February 21, 2001

**SUBJECT: KEWAUNEE NUCLEAR POWER PLANT - REQUEST FOR EXEMPTION FROM THE REQUIREMENTS OF 10 CFR PART 50, APPENDICES G AND H, AND 10 CFR 50.61 (TAC NO. MA8585)**

## **NRC STAFF METHOD EVALUATION**

Figure 1 - Current KNPP RPV Cooldown P-T Limit Curves Through 28 EFPY

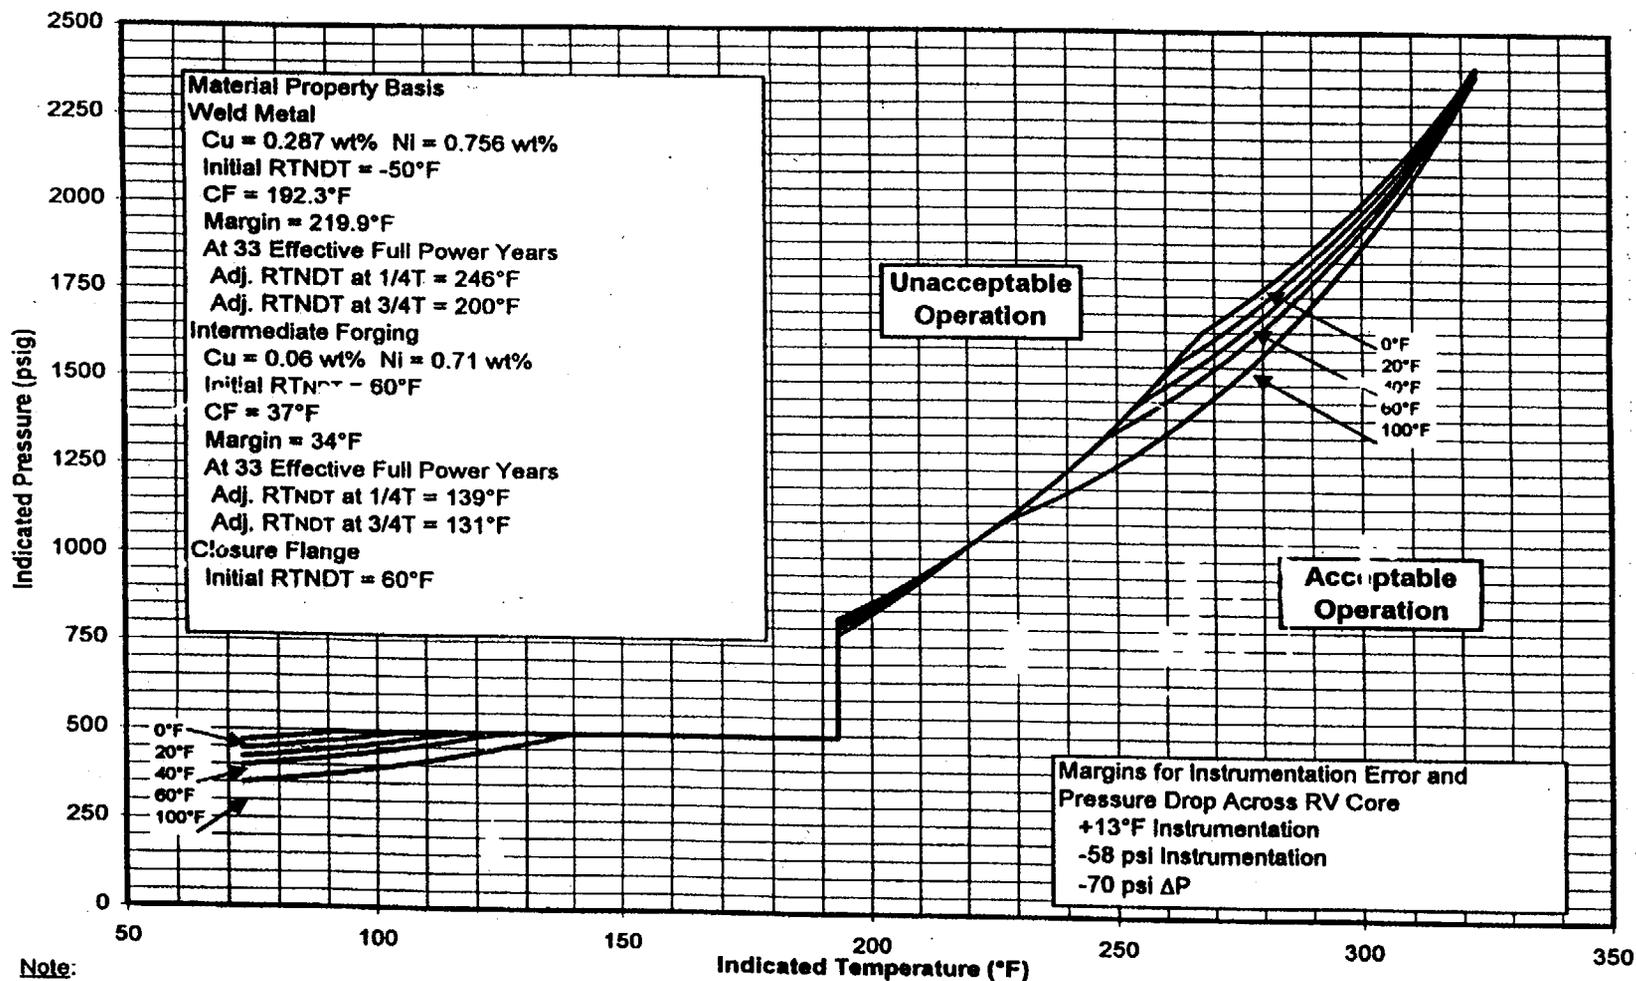
However, the NRC staff did note that in the NRC staff SE which granted approval for the current KNPP P-T limits, a restriction on their validity to 28 EFPY of operation was imposed because the NRC staff calculated the cooldown curves in Figure 1 to be 5 to 7 °F non-conservative at 33 EFPY.<sup>[31]</sup> This was based on the NRC staff's conclusion that the EOL 1/4T and 3/4T reference temperatures for the KNPP RPV circumferential weld (under the Charpy V-notch and drop weight-based methodology) would be 256 °F and 210 °F, respectively. Reestablishing the EOL 1/4T and 3/4T reference temperatures as 247 °F and 196 °F, respectively, using the NRC staff's Master Curve-based approach, "corrects" for this 5 to 7 °F non-conservatism in the current KNPP cooldown P-T limit curves and would justify, if requested by the licensee, their use through 33 EFPY of operation. The NRC staff's prior conclusion, that the other current KNPP P-T limit curves (e.g., the heatup limit curves, which were based on the material properties of the most limiting KNPP beltline forging and the limiting RPV closure flange material) would be acceptable through 33 EFPY, remains valid.

Figure 3 - Plot of Available Data Sets Containing Both PCVN and 1T-CT or Larger Data to Estimate the Bias in PCVN  $T_0$  Results as a (Potential) Function of the Constraint Parameter,  $M_0$  for the PCVN data set.

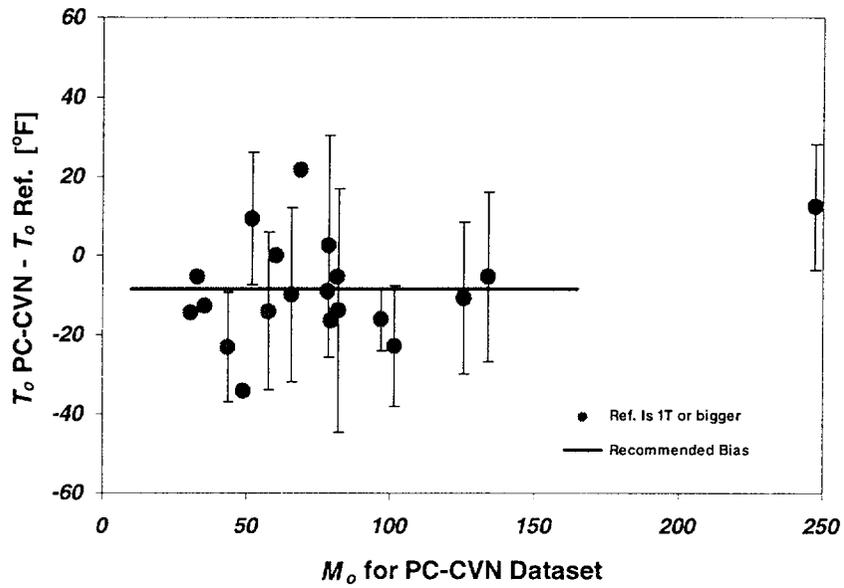
In Figure 3, “ $T_0$  PC-CVN” is the  $T_0$  value determined for a particular material based upon the testing of PCVN specimen sets per ASTM E1921-97 (including the censoring limit) and “ $T_0$  Ref.” is the  $T_0$  value calculated for the same material from larger specimens. Thus, the ordinate axis in Figure 3 represents the difference in calculated values of  $T_0$  with negative values indicative of a potentially non-conservative bias in the  $T_0$  value determined from the PCVN data set. This  $T_0$  differential was then plotted relative to the constraint parameter,  $M_0$ , which is the non-dimensional deformation level associated with  $K_0$ , the 1T equivalent  $K_{JC}$  value associated with the 62.3 percent cumulative failure probability from the data derived from the

From Figure 3, the NRC staff concluded that although a statistically significant bias of 8.5 °F was evident in the data, no defined trend with  $M_0$  was able to be resolved. The NRC staff also observed other data points for which " $T_0$  Ref." values could be calculated from specimens as small as 0.5T-CTs. With the inclusion of this additional data, a trend of increasing PCVN bias with decreasing  $M_0$  may have been resolvable, but the complication of including data wherein the size (and thus the expected constraint) of the specimens used to define " $T_0$  Ref." was nearly the same size as the PCVN specimens would have made any such conclusions highly speculative. It can, however, be noted that with regard to addressing bias related to the licensee application, either interpretation would have yielded the same net effect in the NRC staff's overall methodology.

The NRC staff acknowledges that the lack of a definable trend in Figure 3 calls into question whether the observed bias from PCVN test results can be simply addressed as a matter of specimen constraint. Other theories have been postulated, including consideration of specimen geometry and T-stress, to explain the observed differences in PCVN and CT specimen results. The NRC staff recognizes that additional research in this area may help to better define this issue and modify the conclusions of this SE. However, the NRC staff concludes, at this time, that the assumption of a 8.5 °F bias in PCVN-based  $T_0$  values relative to values obtained with larger size CT specimens, to be applied to each unirradiated and irradiated PCVN data set in the licensee submittal, is adequate to address this potential source of non-conservatism in the NRC staff's methodology as developed in Appendix A to this SE.
